Project Name: OSC Townhomes

Project Location: 202 SE 4th Avenue

SITE PLAN REVIEW AND APPEARANCE BOARD

File No: 2019-147-SPF-SPR-CLV

SITE PLAN
SP-1

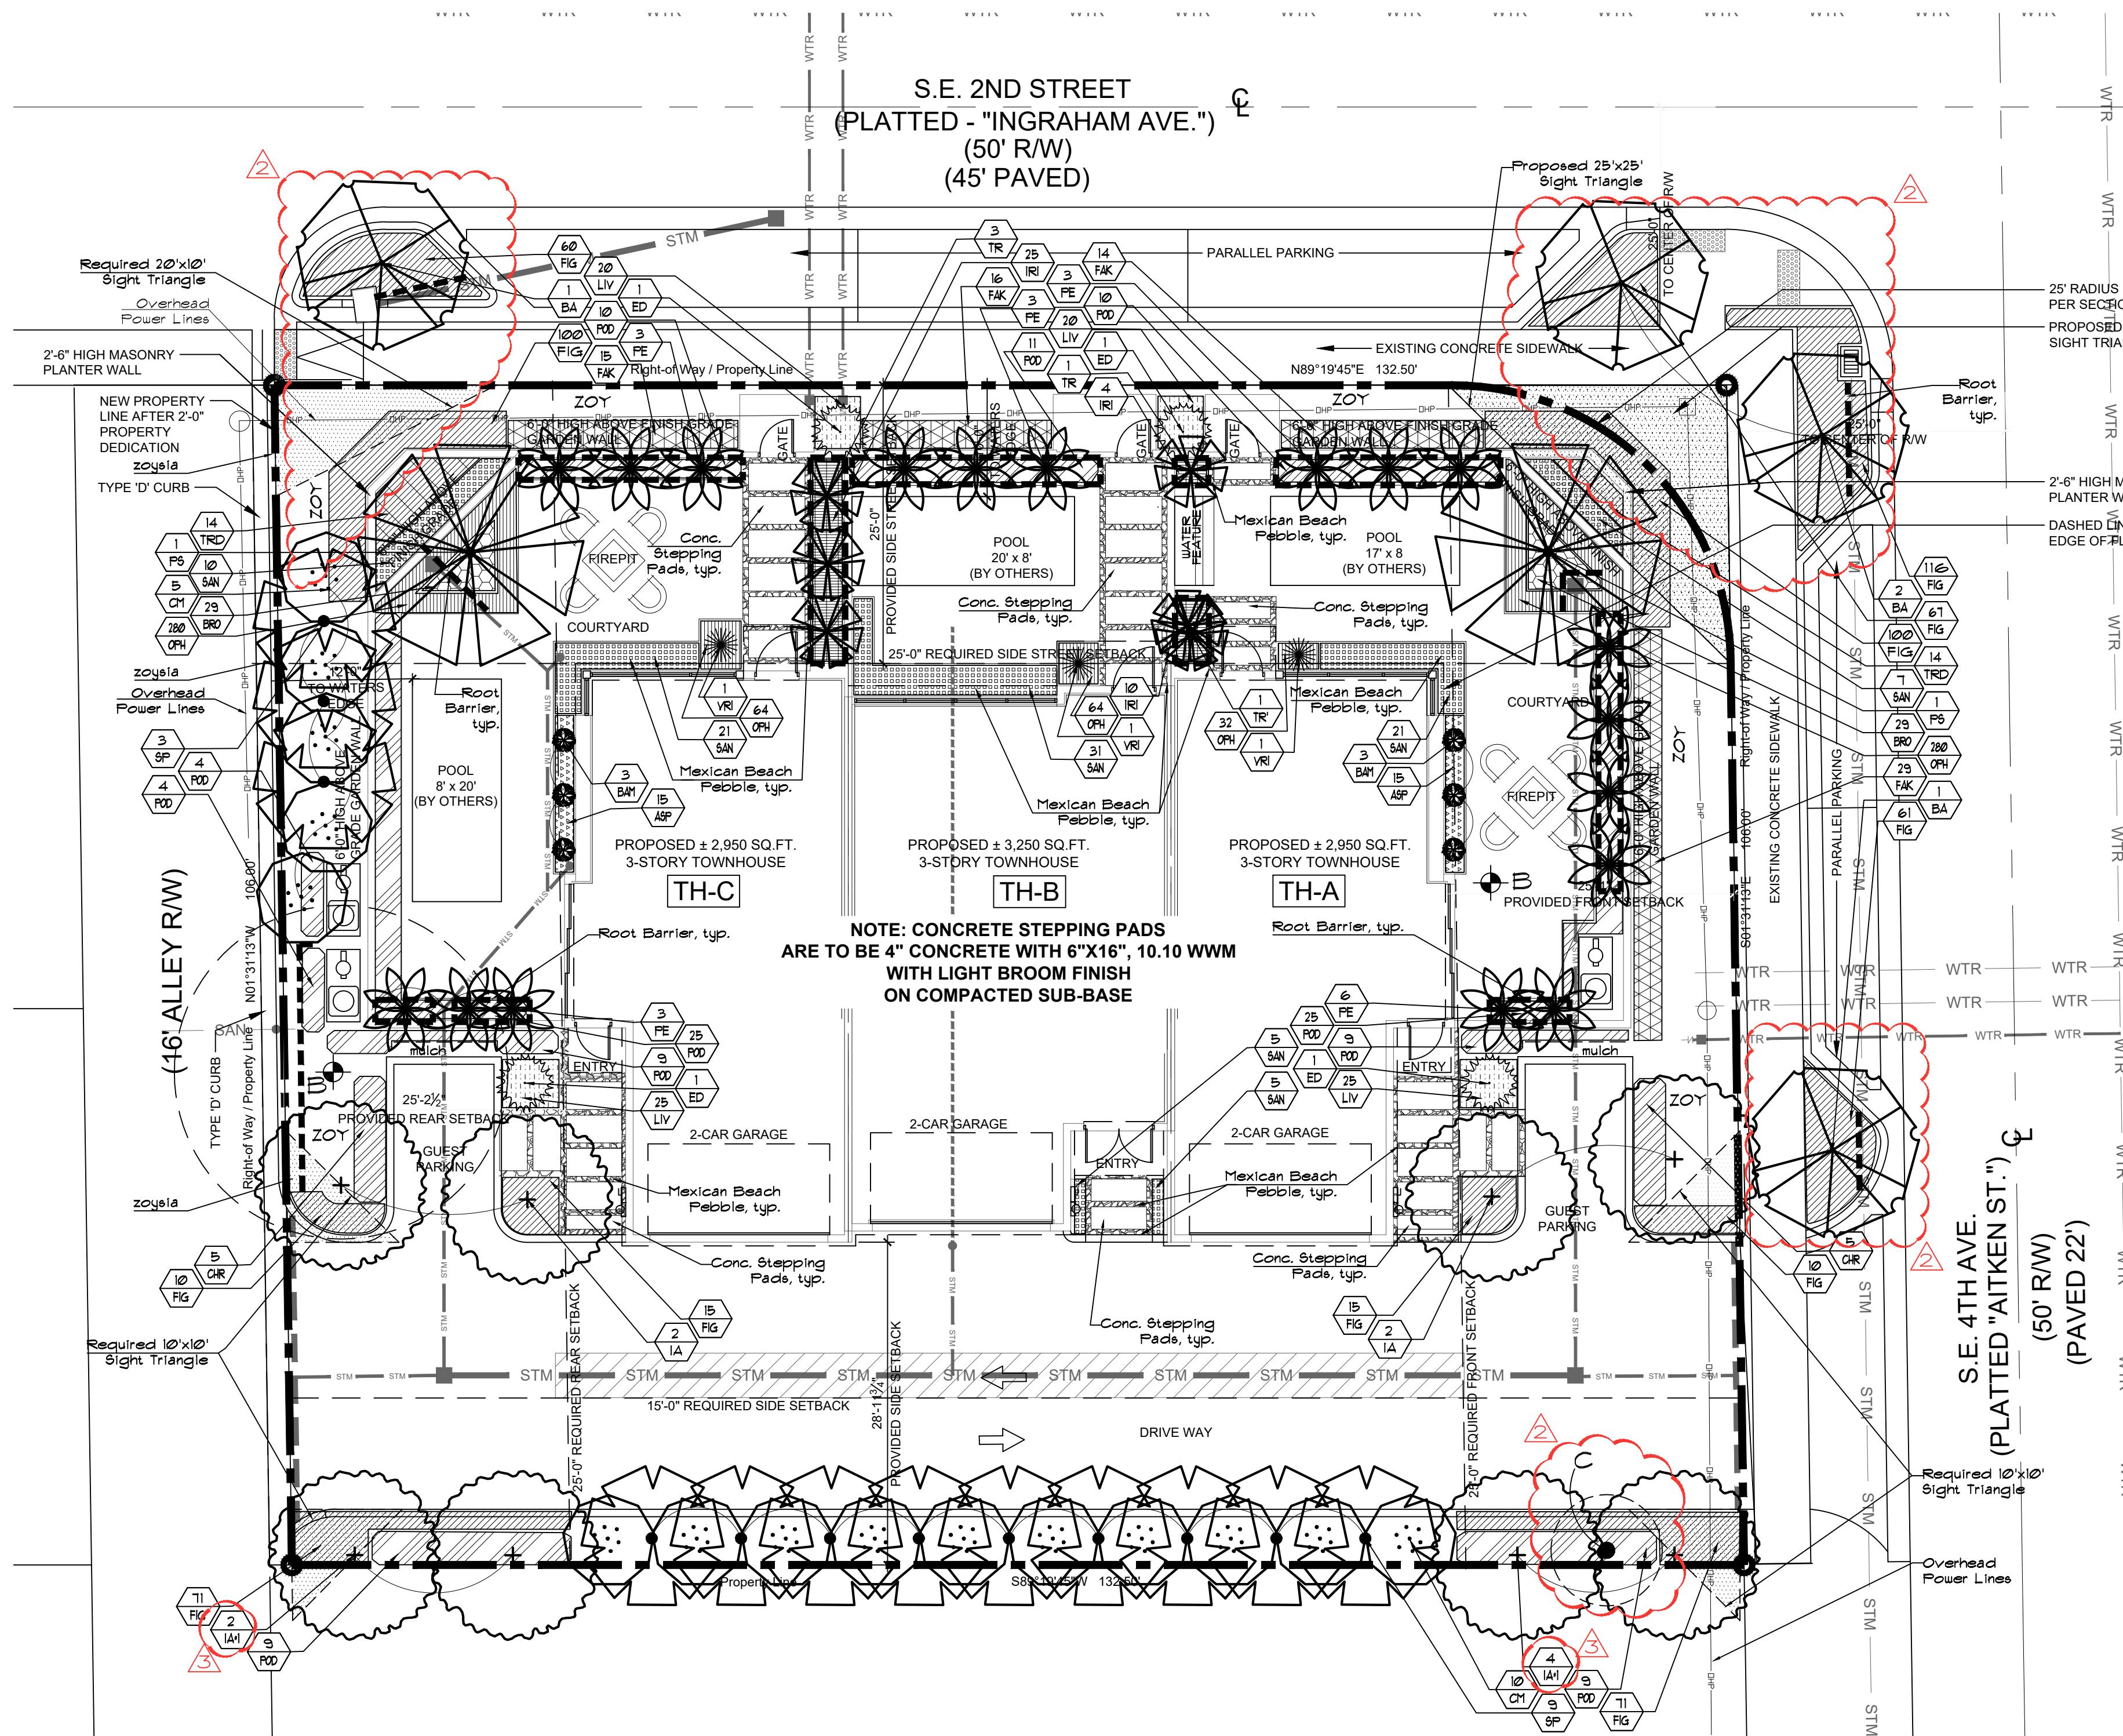
- As shown on page SP-1, the townhomes facing SE 2nd Street have a 2-car garage with a setback of at least 25', thus complying with this requirement.

- Site plan SP-1, shows a 6' high masonry screen wall adjacent to the front yard, side street, and rear yard setbacks. The wall is offset approximately 6' from the property line to allow for landscaping to grow in the front of the walls. Furthermore, the north property line contains two triangular landscape planter beds contained in a 3' tall masonry planter. As shown on page L-2, the proposed Fakahatchee Grass plants shown to screen the concrete walls are identified to be installed at 24" in height at time of planting. The plant material selected in accordance with LDR Section 4.6.5 (E), will grow to a mature height within two years, to be maintained at a height half the size of the wall. The proposed wall and hedge heights comply with the aforementioned LDR section.

- Site Plan page SP-1 shows a 9.8' stacking distance on the west side of the property from the alleyway to the first parking guest parking space, and a 10.3' stacking distance on the east side of the property from SE 4th Avenue (local road) to the first parking spaces. The proposed stacking distances exceed the minimum requirement listed above.

- Site plan page SP-1 shows three private swimming pools on the site. As a result of the limited access easement being provided along the north side of the property, the north side of the property is considered the side street setback, and the west side of the property is considered the rear setback. As shown, the proposed pools for unit TH-A and TH-B are located within the side street back, 10' from water's edge to the property line. The pool shown adjacent to unit TH-C in the rear setback is shown to be 11' from the property line.

- As shown on page SP-1, the existing alleyway is shown to be 16'. As such, the plans show the development is providing a 2' dedication along the alleyway to contribute to the required 20' ROW minimum requirement for alleys in accordance with 5.3.1(D)(2) Table T-1.

NORTH
L-2

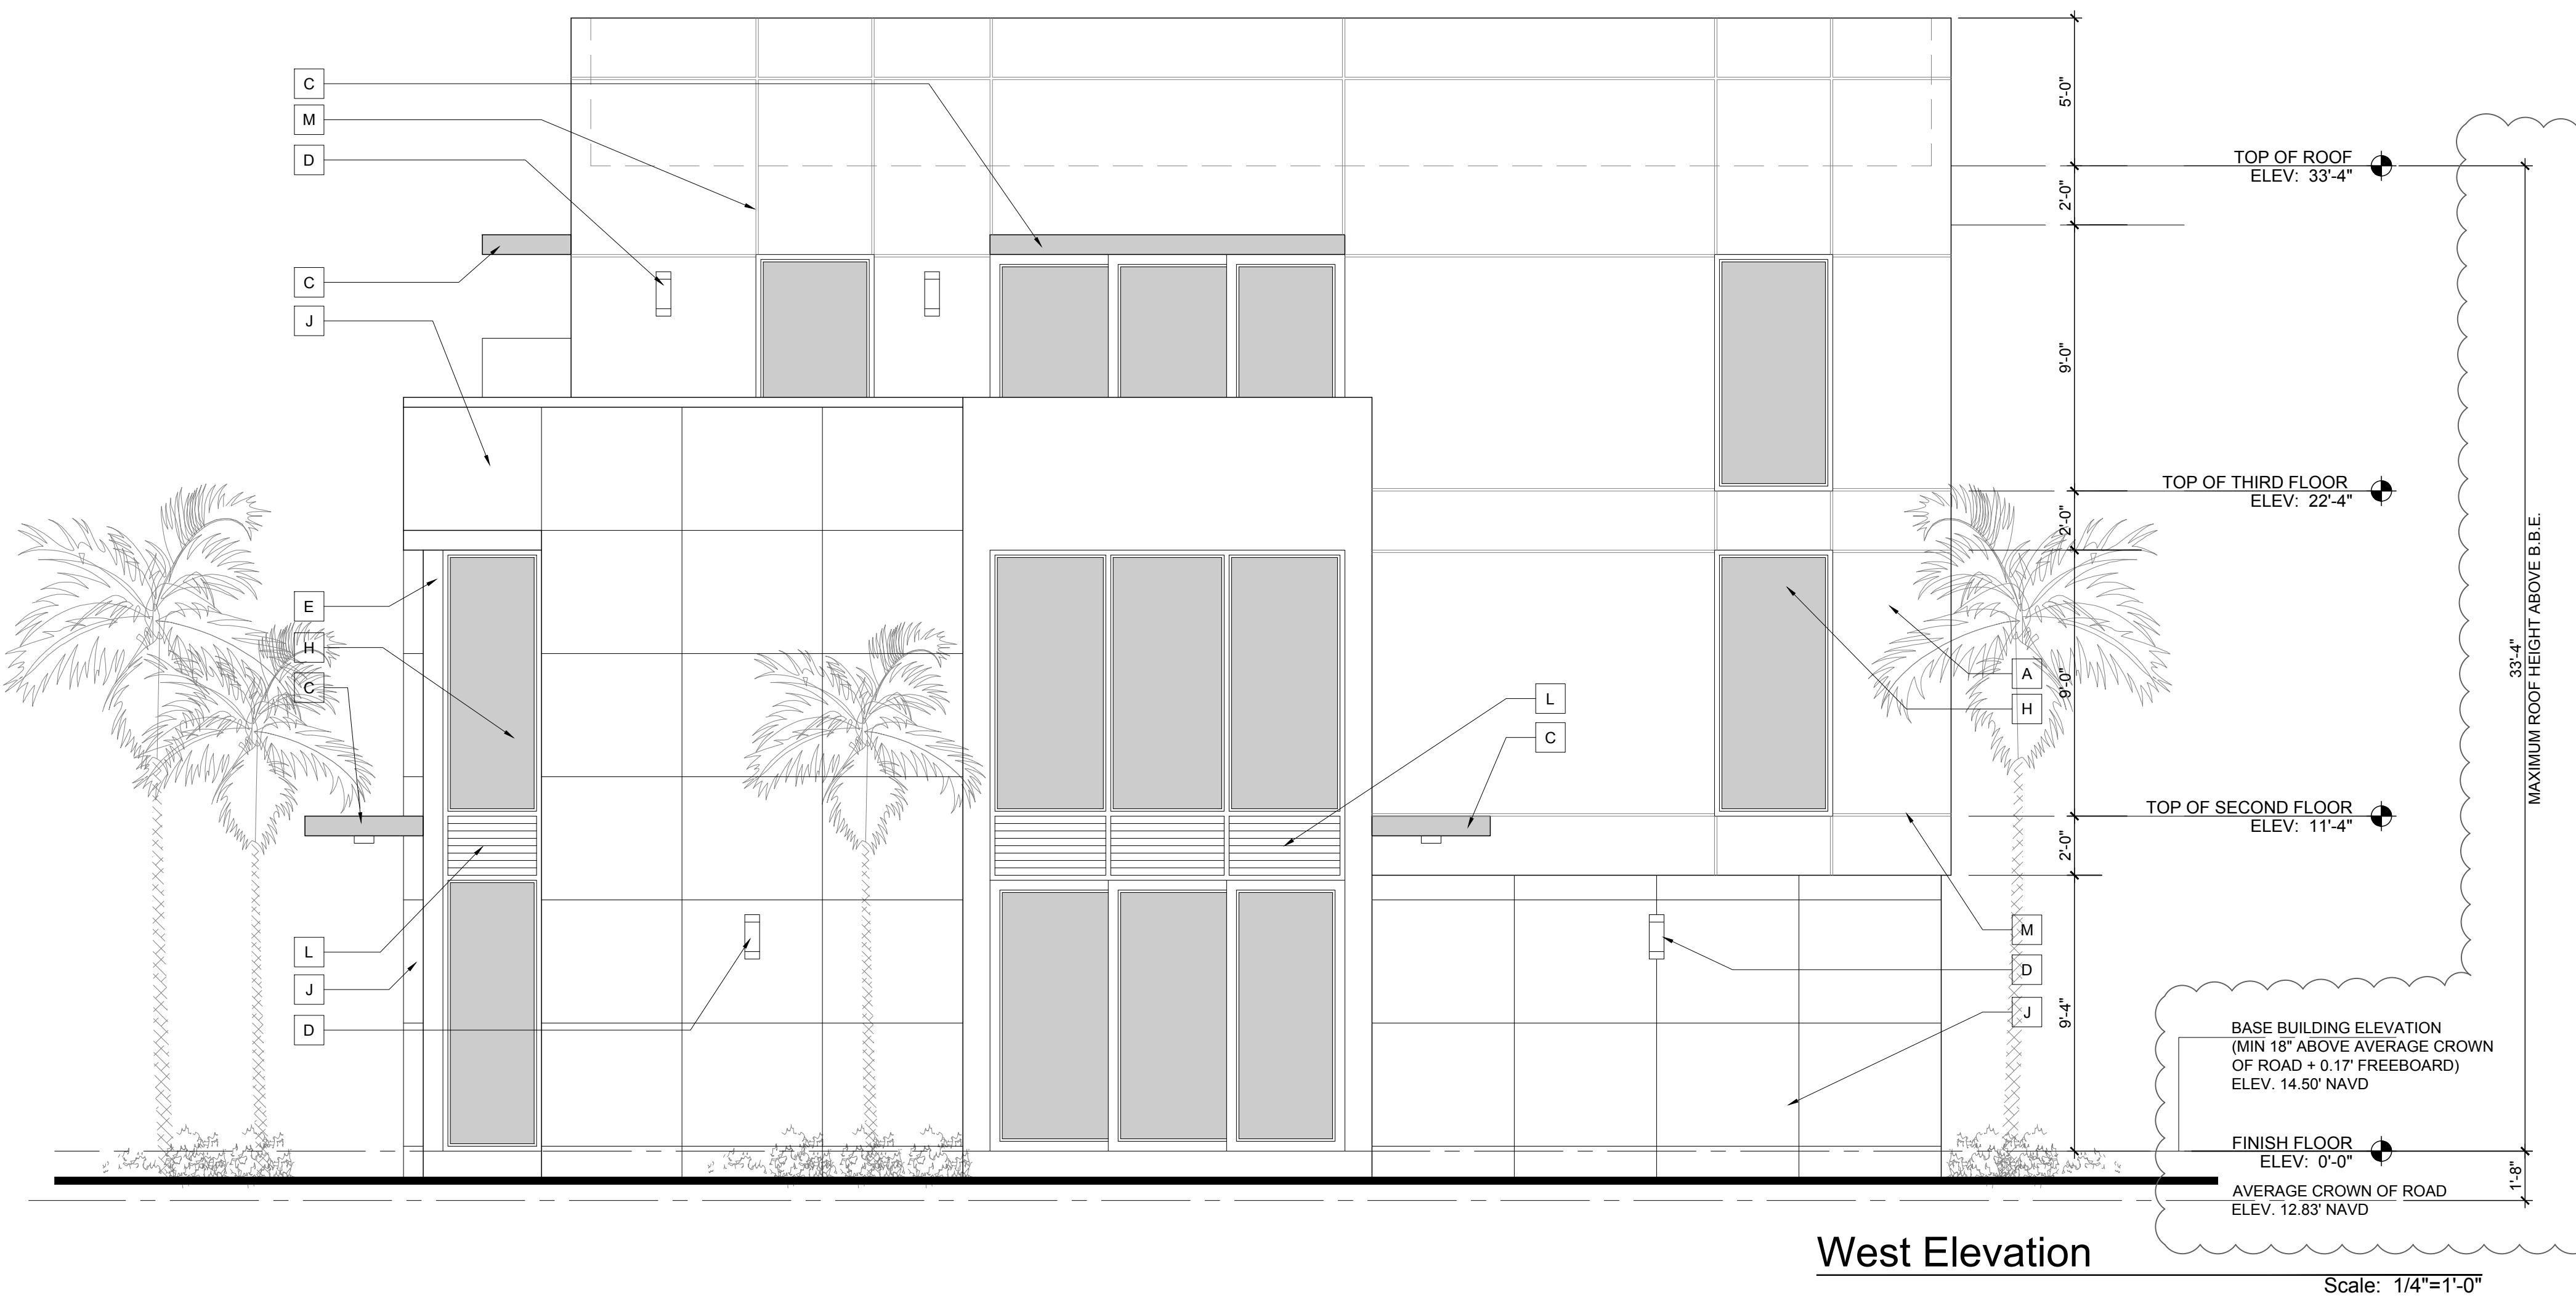
Specifically, plan page L-2 shows a row of 13 trees adjacent to the south property line placed 8' to 14'

feet on center to create a dense continuous buffer of trees. The trees provided will be made up of canopy trees and palm trees. The Holly trees are specified at a height of 20', Fishtail Palm are specified at 16' in height, and the Sable Palms are specified at a height of 26'. The Sable Palms and the Holly trees specified are over 25% larger in height than what is specified in the code as required in this LDR section.

Planner. Plan page L-1 shows that the development is proposing to relocate one Mahogany Tree, and keep one Cabbage Palm tree. Furthermore, the plan shows the removal of two Seagrape trees and one Green Buttonwood tree. Plan page L-2 shows a lush variety of native and Florida Friendly landscape material proposed for the development. The quantity and size comply with the minimum requirement listed in the LDR. The landscaping selected along SE 2nd Street and SE 4th Avenue are composed of a row of Solitaire Palm trees with ornamental grasses and foundation plant material. The two corners of the property adjacent to SE 2nd Street feature raised triangle planter beds in front with Sylvester Date palms, which aesthetically frame from the front of the buildings. Along the west property line, a row of Sable palm trees with foundation plants and ornamental grasses buffer the property from the adjacent alleyway. As previously mentioned, adjacent to the south property line features a row of East Palatka Holly trees spaced 15' on center, Sable Palms spaced 8' on center and a continuous row of shrubs. Additionally, the landscape material provided along the south property line provides a buffer from the higher density use of the subject property to the lower density Single-Family zoned properties to the south.
